Access Compliance Report

Public Rights-of-Way

(Curb Ramps)

Intersection ID: 44778	Main Street: SILVER_CRESCENT_DR	Cross Street: VENDOME_ST	Location: SW
ADA ID: E95FE5E1E17E	Ramp Type: Directional1	Initial Pass/Fail: Fail	Overall Compliance: No
Severity Score: 12.5			
Codes/Mitigation Info/Possible Solution		Field Measurements/Component Compliance

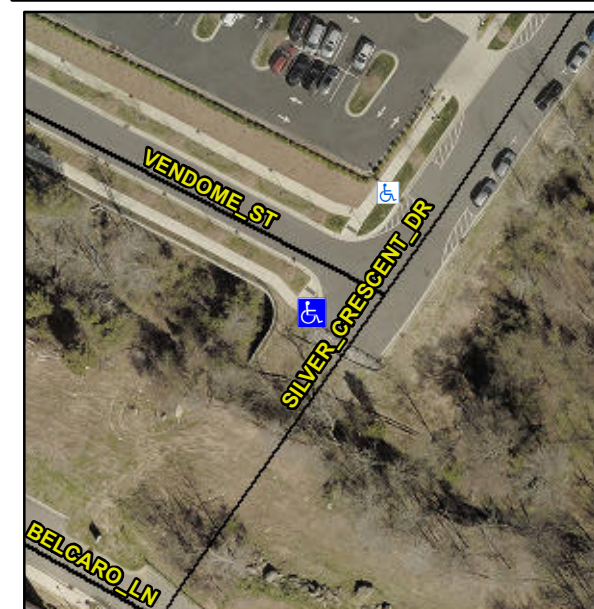
R304.5.3

Compliance	Description	Data	Compliance	Description	Data
N/A	Ramp Length (in)	90.0	N/A	Grade Break?	N/A
Yes	Ramp Width (in)	70.0	N/A	Grade Break Slope (%)	0.0
Yes	Ramp Slope (%)	4.0	N/A	Grade Break XSlope (%)	0.0
No	Ramp XSlope (%)	6.3			
N/A	Flare Type LT	N/A	N/A	Flare Type RT	N/A
N/A	Flare Slope LT (%)	N/A	N/A	Flare Slope RT (%)	0.0
N/A	Flare Traversable LT?	N/A	N/A	Flare Traversable RT?	N/A
N/A	Landing Length (in)	0.0	N/A	DWS Provided?	N/A
N/A	Landing Width (in)	0.0	N/A	DWS Contrast?	N/A
N/A	Landing Slope (%)	0.0	N/A	DWS Length (in)	N/A
N/A	Landing X Slope (%)	0.0	N/A	DWS Full Width?	N/A
N/A	Landing Curb? (Y/N)	N/A	N/A	DWS Offset LT (in)	N/A
N/A	Shared Landing?	N/A	N/A	DWS Offset RT (in)	N/A
N/A	Gutter Ponding?	0.0	N/A	Gutter Slope (%)	N/A
N/A	Gutter Lip Ht (in)	0.0	N/A	Gutter X Slope (%)	N/A
N/A	Painted X Walk1?	No		Road Slope (%)	3.9
	X Walk 1 Direction	To NE		Road X Slope (%)	1.4
	X Walk 1 Width (in)	N/A		Clear Space?	N/A

Remove & Replace Entire Ramp.
